COUNCIL ASSESSMENT REPORT

Panel Reference	PPSSCC-265
DA Number	DA/587/2021 PAN-111258
LGA	City of Parramatta Council
Proposed Development	Development of proposed Sub-Precinct 3 comprising subdivision into 6 lots, remediation, construction of roads and pocket park, and construction a residential flat development (3/6/9/28 storeys) containing 323 apartments.
Street Address	14-16 Hill Road – Sydney Olympic Park Lot 3 DP 271278
Applicant Owner	SH Hill Road Development Pty Ltd SH Hill Road Development Pty Ltd
Date of Lodgement	2 July 2021
Number of Submissions	7 submissions (5 x households)
Recommendation	Approval subject to conditions
Regional Development Criteria	General Development >\$30 million
List of All Relevant s4.15 Matters	<ul style="list-style-type: none"> • Environmental Planning and Assessment Act and Regulations • SEPP (Planning Systems) 2021 • SEPP (Biodiversity and Conservation) 2021 • SEPP (Resilience and Hazards) 2021 • SEPP (Transport and Infrastructure) 2021 • Auburn LEP 2010 • Wentworth Point Precinct DCP 2014 • Auburn DCP 2010

List of Relevant Documents	As appearing in Condition 1 of Attachment B
Report Prepared By	Kate Lafferty – Executive Planner
Report Date	28

Unit Amalgamation Potential Option – Building H Tower

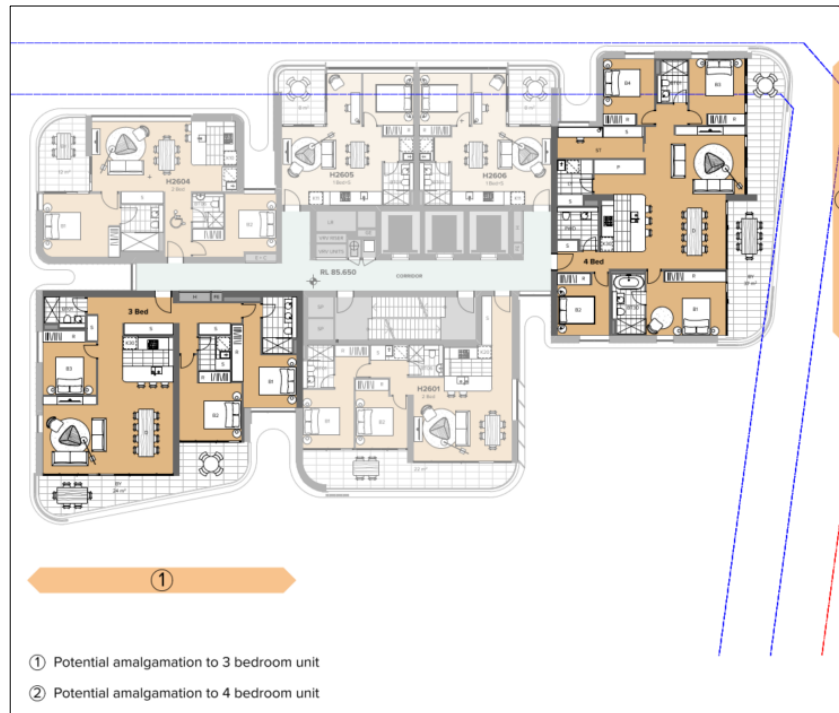
Council would ordinarily expect a higher percentage of 3 bedroom units within the development (minimum 10%) and has encouraged the applicant to provide a greater diversity of unit sizes. It is noted that there are no unit mix requirements in either the Wentworth Point Precinct DCP or the Auburn DCP. The applicant has not amended the unit mix however has shown how apartments are capable of being amalgamated to provide larger units should the market demand this type of accommodation.

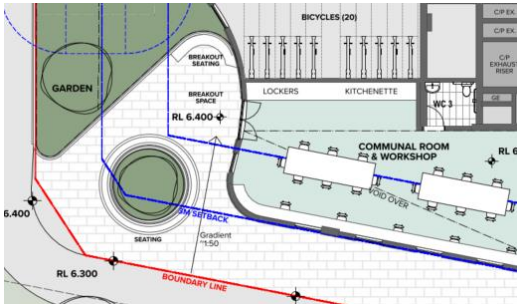
DEAP Comment	Planning Response	Action
Concerns about the civic quality of this precinct are still held awaiting full integration on the public domain and infrastructure related to the entire site.	Council's Urban Design team have assessed the public domain masterplan and are satisfied that the civic quality of the precinct is of an acceptable standard.	Nil
One area of concern remains relative to the lack of integration of the substations. The Panel recommends that they be either integrated into the building or within a	2 x substations are located on the southern setback of the building adjoining the "back of house" infrastructure. The location of the substations is not in a prominent position within the development	Nil

thoughtful public domain structure as proposed for SP6.	site and is adequately surrounded by landscaping. In this instance, the proposed substation location is considered acceptable.	
<p>It was noted that areas for p/v solar panels are shown on roof plans for Building J but none are shown for Building I and H, the final extent should be clarified. Further detail is required for:</p> <ul style="list-style-type: none"> on-site water retention for use in irrigation of planting ceiling fans for bedrooms and living areas clearly marked on the plans roof slabs with foam insulation and pebble ballast for thermal comfort window options (other than sliding doors) that provide cross ventilation. <p>The Panel has raised concerns regarding suitable exterior solar control measures particularly on the western façade and this is still not satisfactorily addressed. The increased depth of mullions does not in the Panel's opinion constitute effective shading for solar gain impacts. Adjustable vertical blades of louvres of a suitable depth are considered to be a more effective solution for this façade. It is recommended that Council's ESD consultant undertake a final review prior to final assessment.</p>	<p>The subject proposal is accompanied by a BASIX Certificate which addresses issues in relation to consumption of water and thermal performance of the building and demonstrates that the building achieves an acceptable outcome.</p> <p>Further detail is not considered warranted and although such matters may improve the proposal, there are no DCP or ADG requirements that necessitate the additional matters be provided.</p> <p>Council's ESD consultant has not raised any concerns with the thermal comfort within the residential apartments.</p>	Nil

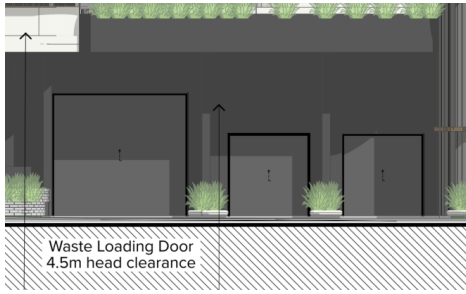
A minor issue that should be addressed is the differing door heights of the loading dock versus vehicle entry points. This should be addressed by proposing a better integration of door heights and appearance plus the possibility of adding a projecting pergola type structure to allow for extended	The differing door heights are a reflection of the needs of separate uses – being the loading dock versus vehicle entry points. In order to improve the visual impact of this service area, it is considered that pergola structures could be placed over the entrance to the vehicle entry points.	Condition

<p>greenery and softening the appearance of this component of the scheme.</p>  <p>Waste Loading Door 4.5m head clearance</p>	<p>This would provide for some improved visual interest on the southern elevation.</p>	
<p>DEAP Summary: SP3 has undergone improvements throughout the review process and the final proposal is considered to generally be of a high standard.</p>
